Access Compliance Report

Public Rights-of-Way

(Pedestrian Signals)

Intersection ID: N/A	Main Street:	Cross Street: N/A	Location: N/A
ADA ID: E20547E3F0AC	Signal Type: One Push Button-Non APS	Overall Compliance: No	Severity Score: BTN 1: N/A BTN 2: N/A No BTN: N/A
Codes/Mitigation Info/Possible Solution		Field Measurements/Component Compliance

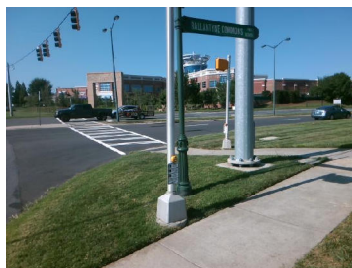
PROW/ADA: TMUTCD 4e.08, R404.2, R404.3, R406.2, R404.7.2

Possible Solutions: Replace Signal Push Button With APS Button on New Post. Remove & Relocate Sign.
